5807 Surrey Street, Chevy Chase  
(HPC Case No. 35/36-08A)  
Somerset Historic District

## HISTORIC PRESERVATION COMMISSION

SUBJECT: Historic Area Work Permit #493720, fence installation

**EXPEDITED**  
**MONTGOMERY COUNTY HISTORIC PRESERVATION COMMISSION**  
**STAFF REPORT**

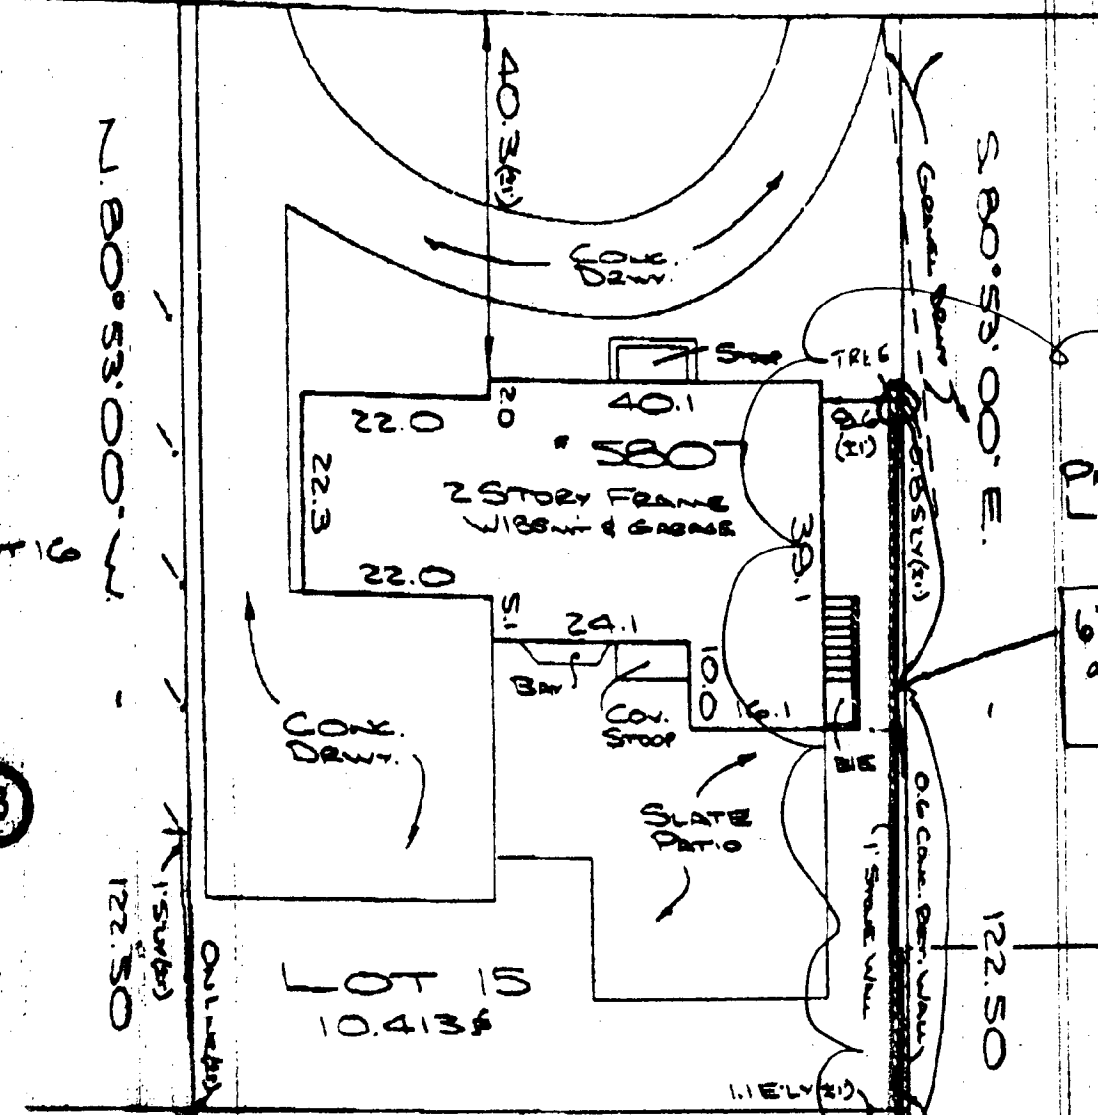
The applicants are proposing to install a 6'5" high, double-sided solid board wooden fence along the northern property line. The proposed fence will begin parallel with the front plane of the house and extend the entire length of the northern property line into the rear yard. The proposed fence height has been requested by the applicant to mitigate the ambient noise level of an existing side yard air conditioning unit on the adjacent property to the north.

Although the HPC does not generally approve fences higher than 4' when forward of the rear plane of the house they have allowed higher fences on a case-by-case basis. This proposal is representative of several alternative noise abatement plans proposed by the applicant aimed at reducing ambient noise levels on the adjacent non-contributing resource property to the north. Alternative noise abatement strategies included the relocation of the side yard air conditioning units to the front yard of the property which also included the installation of a 4'6" high wooden fence. The proposed fence is confined to the side yard of the property and runs between the two houses. Staff supports this alternative because it maintains a sense of

transparency into the rear yard of these properties when viewed from the streetscape of the historic district.

1. *The applicant will submit details of the proposed fence to staff for review prior to stamping permit set of plans.*

1. The applicant will submit details of the proposed fence to staff for review prior to stamping permit set of plans.

PROPOSED WASTE BARRIERS LOCATION

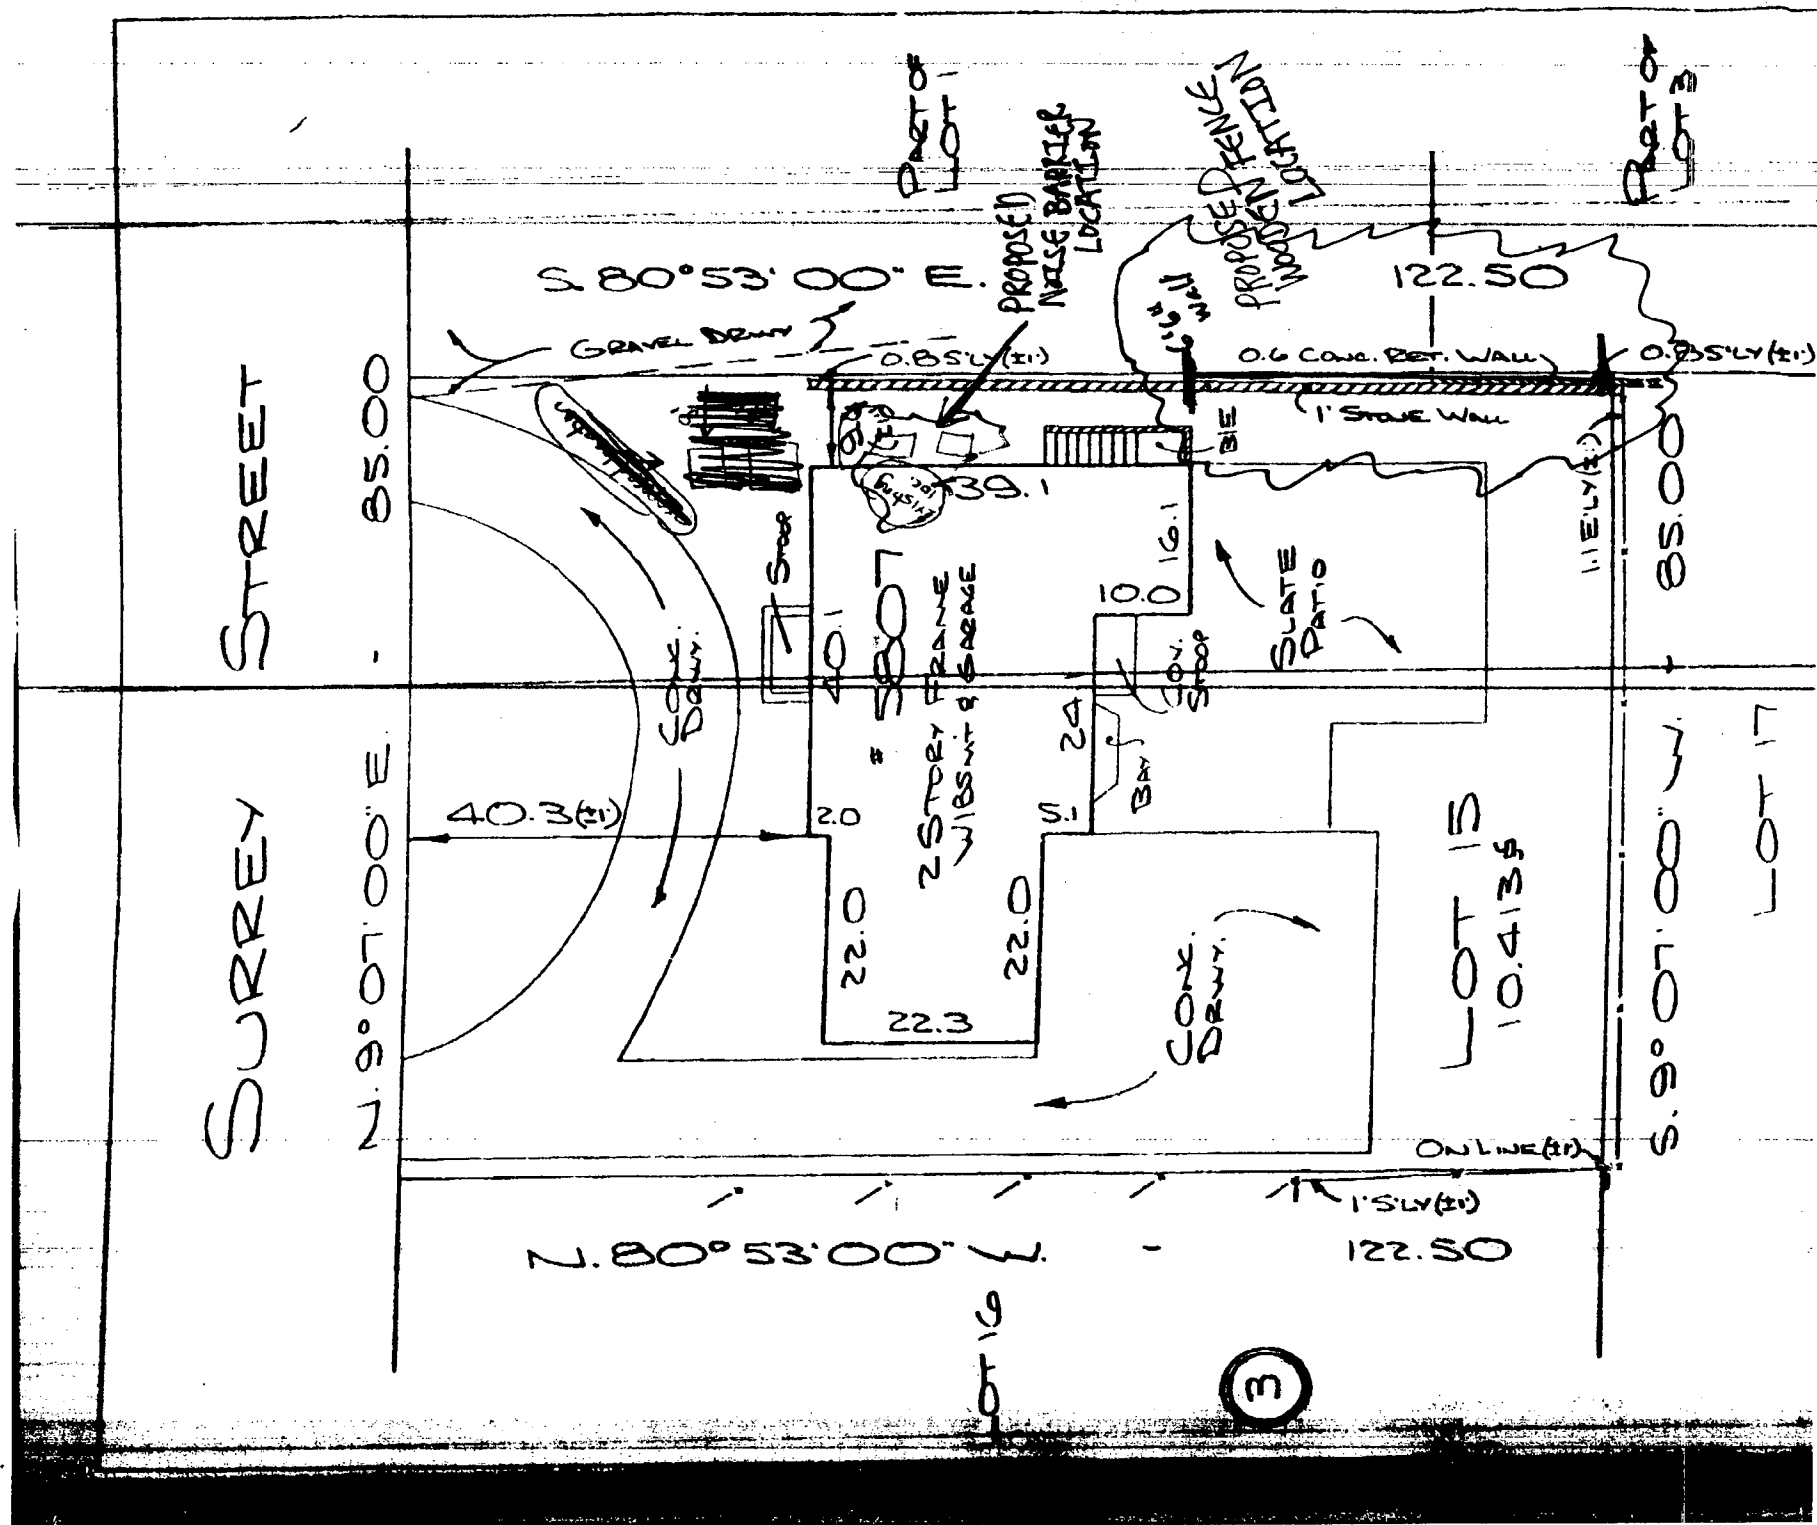
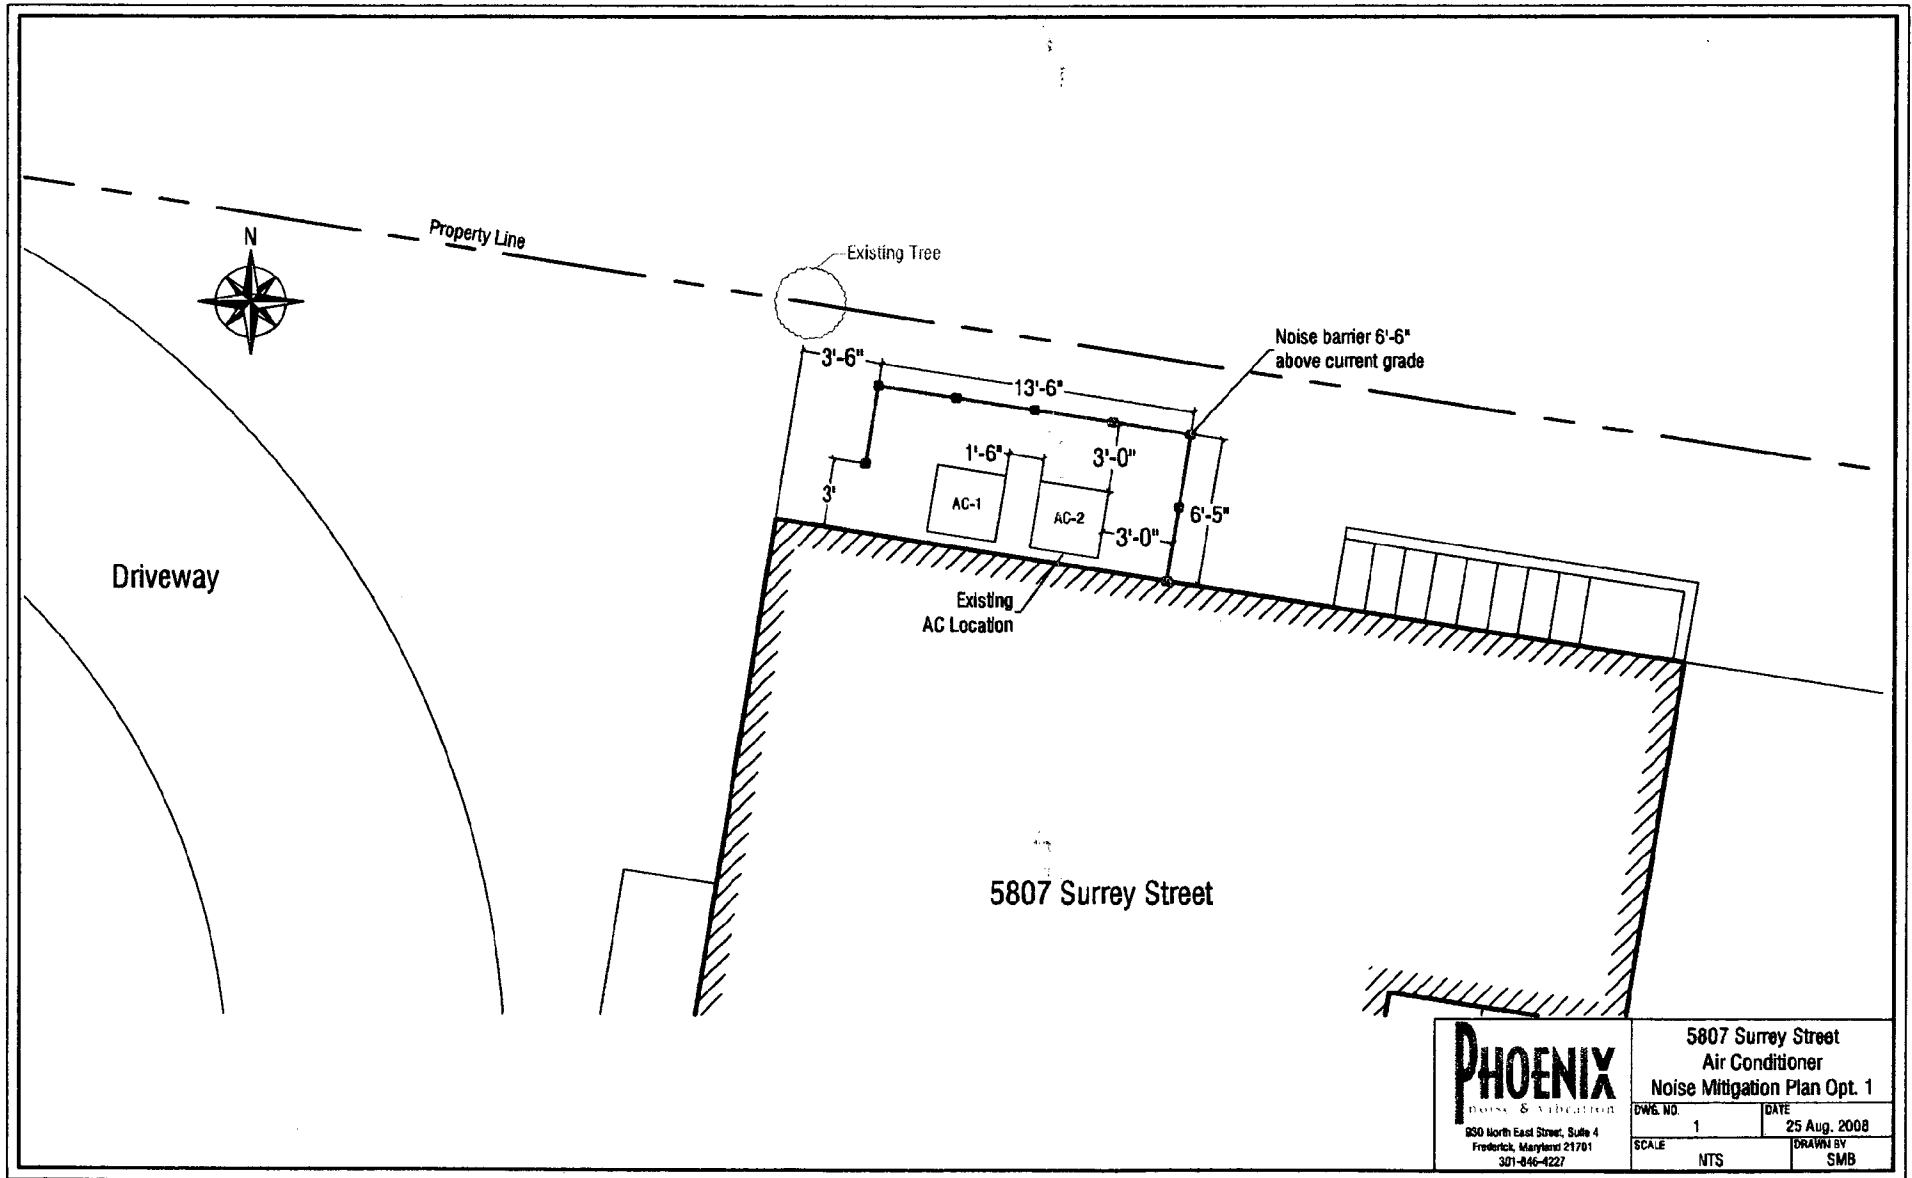
The applicants are proposing to enclose two existing air-conditioner units that are located forward of the rear plane of the house with a 13'6" x 6'5", 6'6" high wooden noise barrier and install a 6'6" high wooden fence behind the rear plane of the house along the northern property line. The proposed noise barrier has been determined by a noise and vibration consultant to be the minimum height and dimensions necessary to properly reduce the ambient noise level on the adjacent property.

Although the HPC does not generally approve fences/enclosures higher than 4' when forward of the rear plane of the house they have in rare circumstances allowed higher fences when appropriate. Staff supports the proposed noise barrier and fence installation projects at the subject property. The proposed noise barrier is confined to a location on the side of the house and will be relatively small in terms of its dimensions therefore visibility will be minimal when viewed from the streetscape of the historic district. The applicants also intend to plant additional vegetative screening to mitigate any potential impact to the streetscape of the historic district.

and with the general condition that the applicant shall present the **3 permit sets of drawings to Historic Preservation Commission (HPC) staff for review and stamping** prior to submission for the Montgomery County Department of Permitting Services (DPS) building permits.
